P.C. INDUSTRIAL PARK ADDITION

DRAINAGE CONCEPT PLAN

September 10, 1984

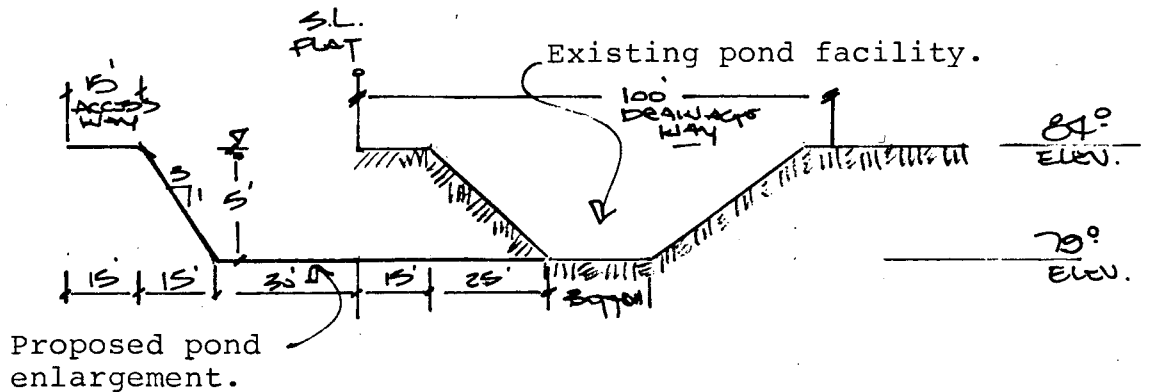
1. Store 5 yr storm instead of 100 yr storm
2. 3:1 side slope instead of 4:1
3. No freeboard
4. VHS's study show ~ 250' Retention
